CAMPUS WIDE, REPLACEMENT/REHAB SAN SEWER SYSTEM CAT 5.5
South Dakota State University
Brookings, South Dakota
OSE# R0323--03X/ARPA
2024

ADDENDUM NO. 1

November 6, 2024

SHEET NO.
1106

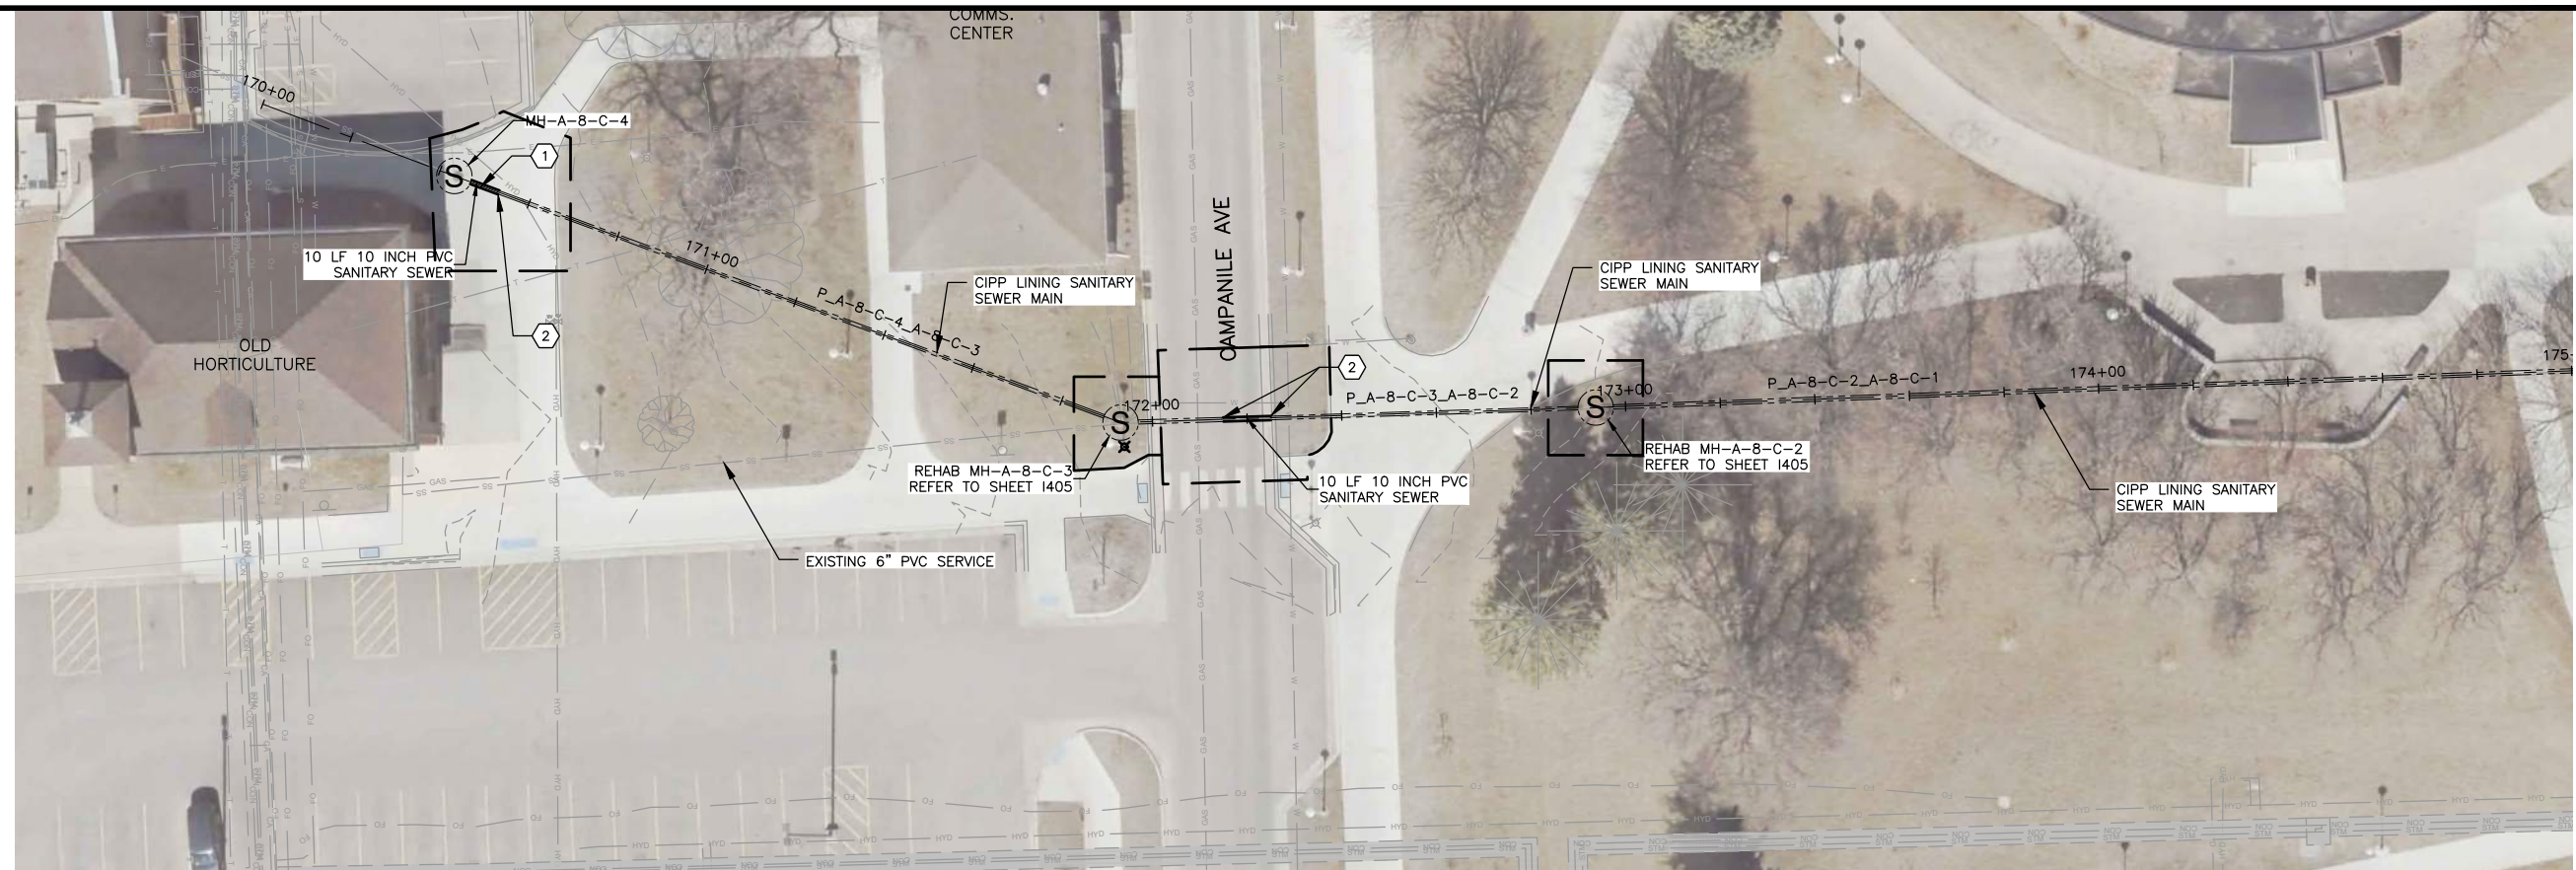
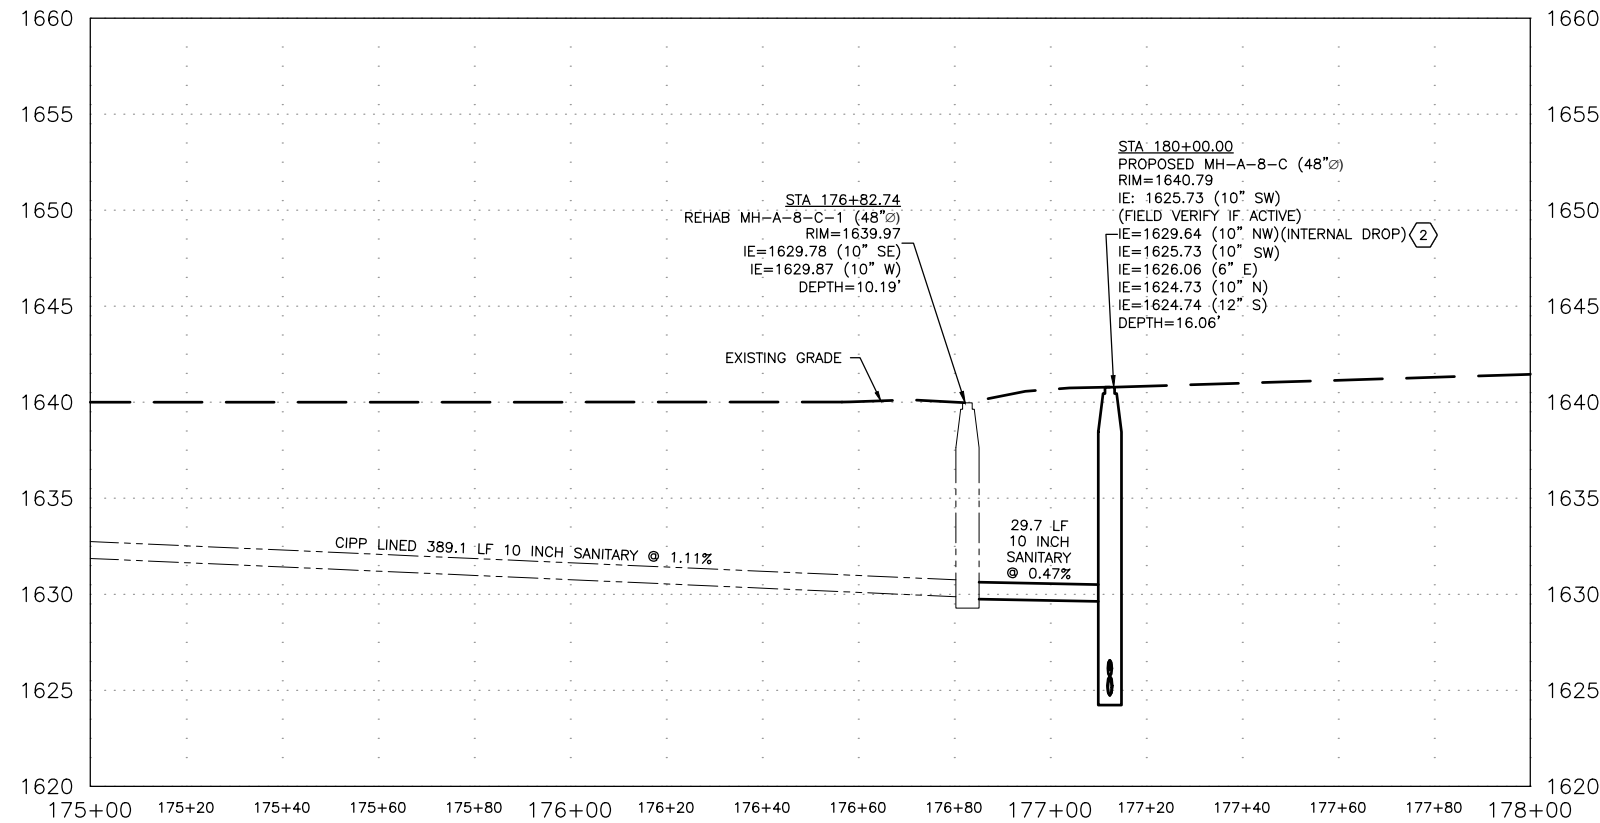
Modified call outs, keynotes, and rehabilitation table.

SHEET NO.
1108

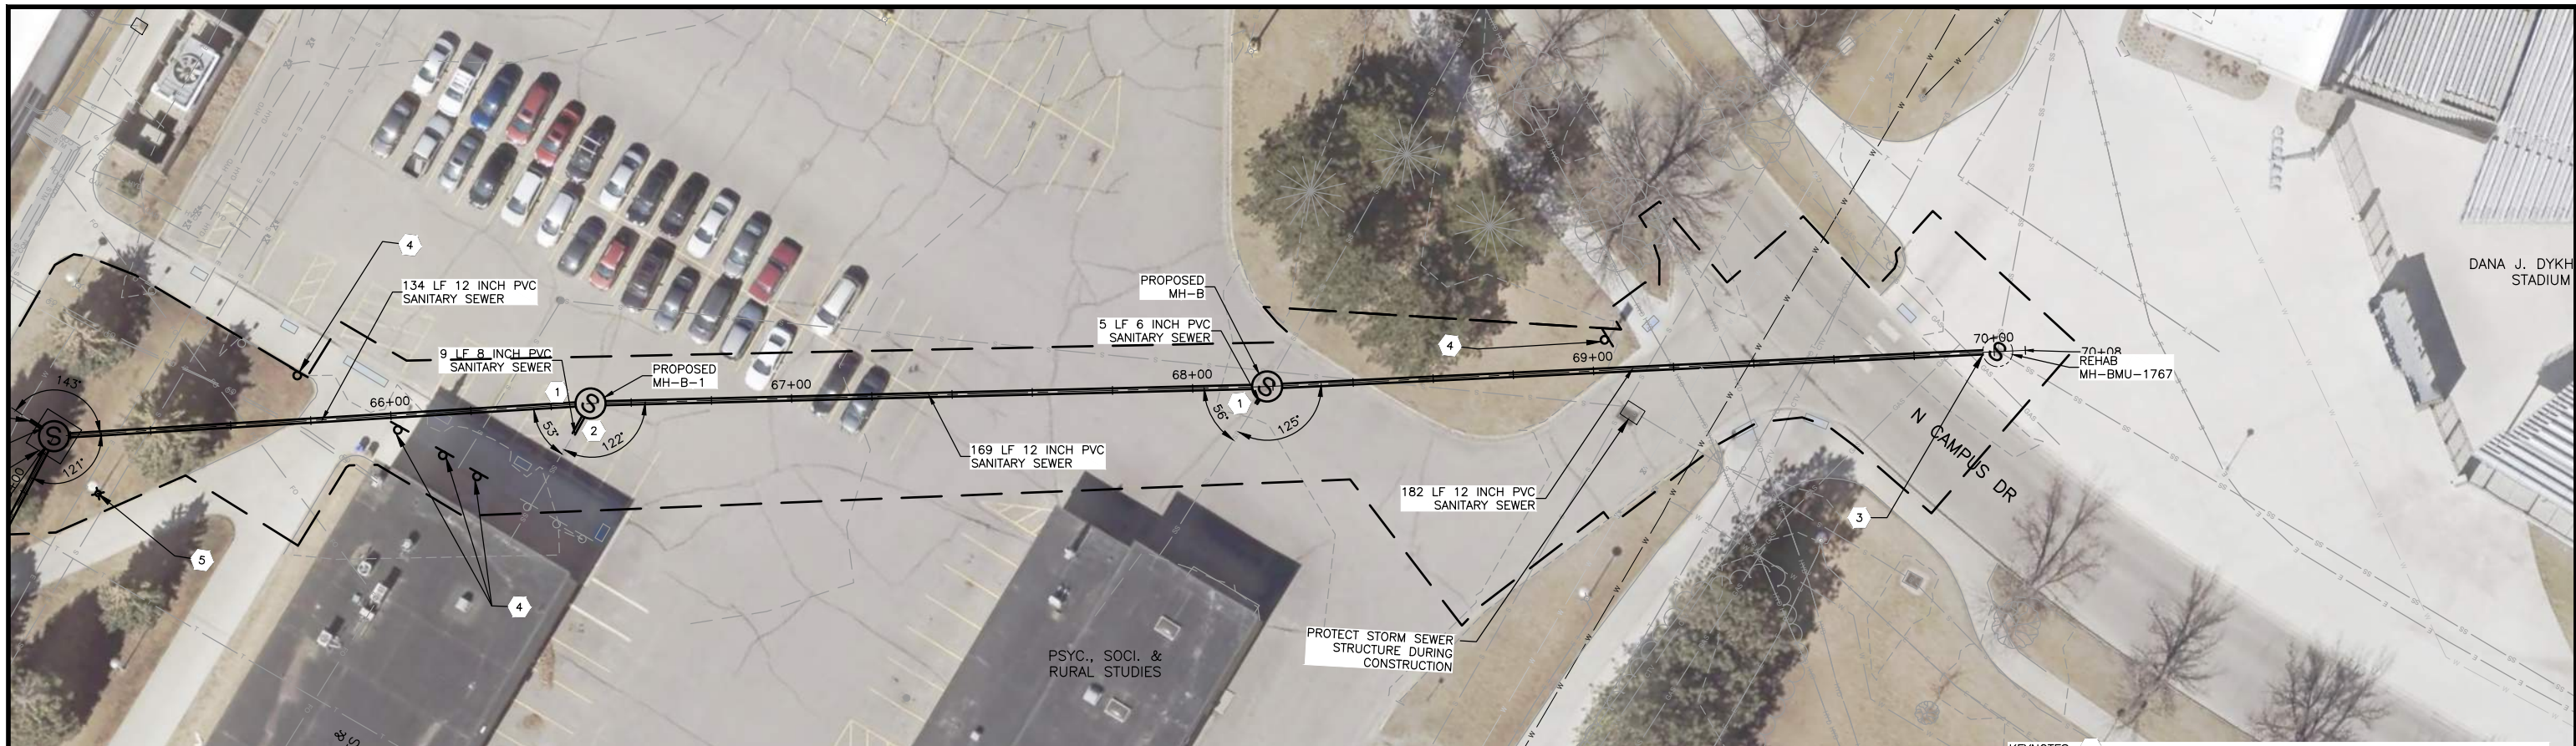
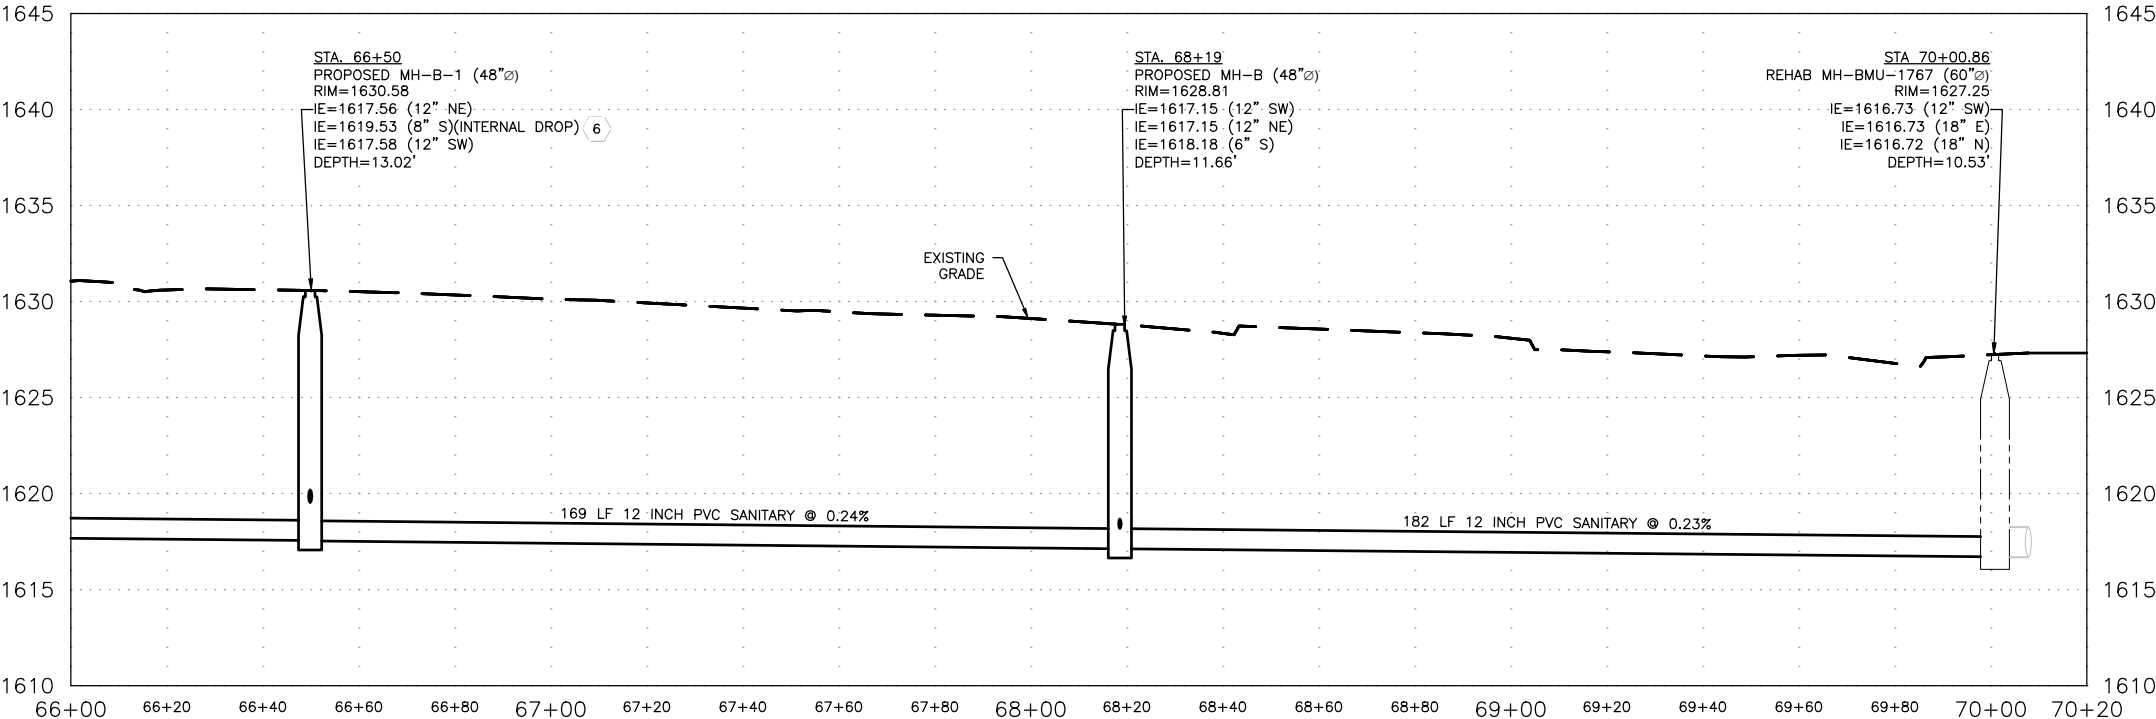
Modified call outs and keynotes.

SHEET NO.
1109

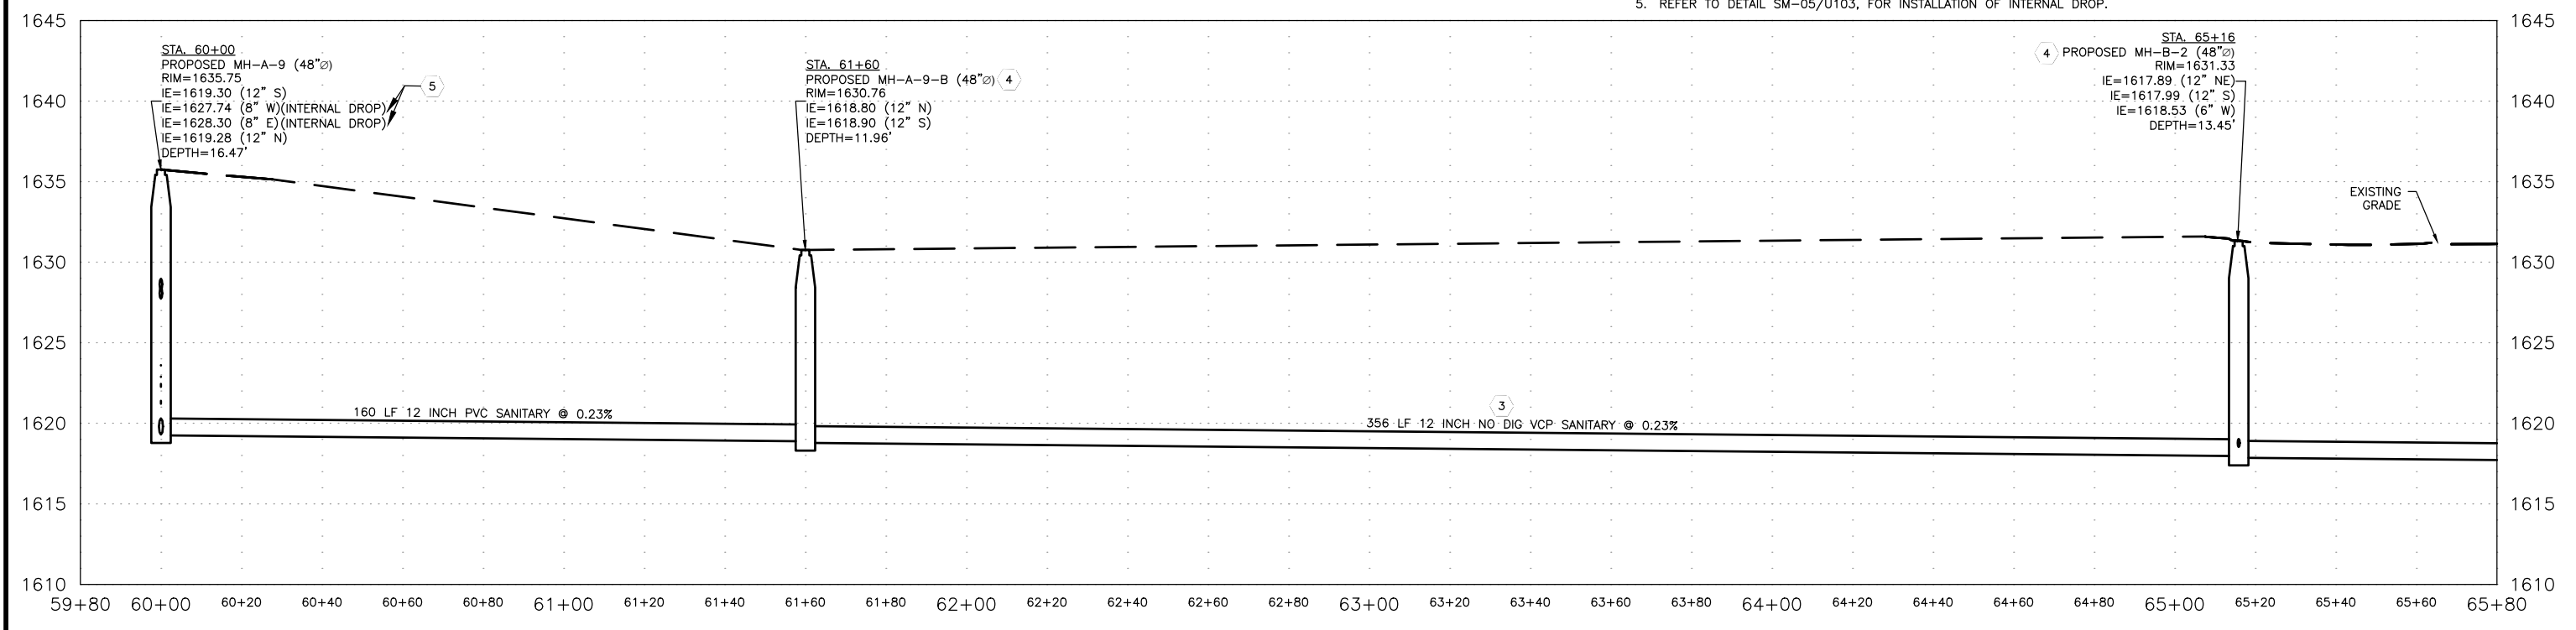
Modified call outs and keynotes.
